Access Compliance Report

Public Rights-of-Way

Intersection ID: 23702	Main Street: COOL_SPRINGS_LN	Cross Street: REA_RD	Location:	W
ADA ID: C5D140C3122F	Ramp Type: PerpDiag	Initial Pass/Fail: Fail	Overall Compliance: No	Severity Score: 12.5

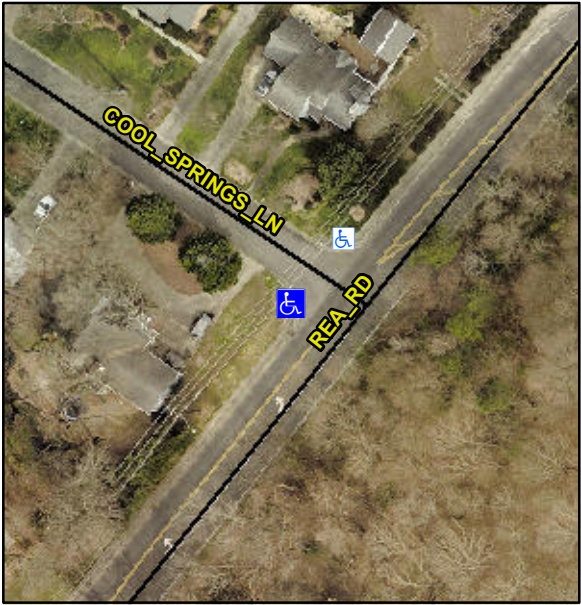
Codes/Mitigation Info/Possible Solution			Field Measurements/Component Compliance		
	Possible Solutions:		Compliance	Description	Data
	Remove & Replace Curb Ramp With Two New Directional Ramps or Equivalent.		No	Ramp Length (in)	48.0
			Yes	Ramp Width (in)	48.0
			N/A	Flare Type LT	N/A
			N/A	Flare Slope LT (%)	N/A
			N/A	Flare Traversable LT?	N/A
			N/A	Landing Length (in)	N/A
			N/A	Landing Width (in)	N/A
			N/A	Landing Slope (%)	N/A
			N/A	Landing X Slope (%)	N/A
<p>Surveyor Notes:</p> <p>N/A</p> <p>PROW/ADA:</p> <p>Not Found, R304.2.2</p>			N/A	Flare Type RT	N/A
			N/A	Flare Slope RT (%)	N/A
			N/A	Flare Traversable RT?	N/A
			N/A	DWS Provided?	N/A
			N/A	DWS Contrast?	N/A
			N/A	DWS Length (in)	N/A
			N/A	DWS Full Width?	N/A
			N/A	DWS Offset (in)	N/A
			N/A	Gutter Ponding?	N/A
			N/A	Gutter Lip Ht (in)	N/A
<p>Total Cost:</p> <p>\$ 3200.00</p>			No	Painted X Walk1?	No
			N/A	X Walk 1 Direction	To SE
			N/A	X Walk 1 Width (in)	N/A

N/A	X Walk 1 Slope (%)	0.7
			N/A	X Walk 1 X Slope (%)	1.4
			N/A	Ramp inside XWalk1?	N/A
			N/A	Road Slope (%)	0.7
			N/A	Road X Slope (%)	0.9
			N/A	Any Obstructions?	N/A
			N/A	Obstruction Type	N/A
			N/A	X Walk 2 Direction	To NE
			N/A	X Walk 2 Width (in)	N/A
			N/A	X Walk 2 Slope (%)	1.3
			N/A	X Walk 2 X Slope (%)	1.4
			N/A	Ramp inside XWalk2?	N/A
			N/A	Clear Space?	N/A
			N/A	Clear Space to XWalk (in)	N/A
			N/A	Storm Grate/Utility Hazard?	N/A
			N/A	Storm Grate/Utility Type	N/A
			Yes	Surface Condition? (G/P)	Good
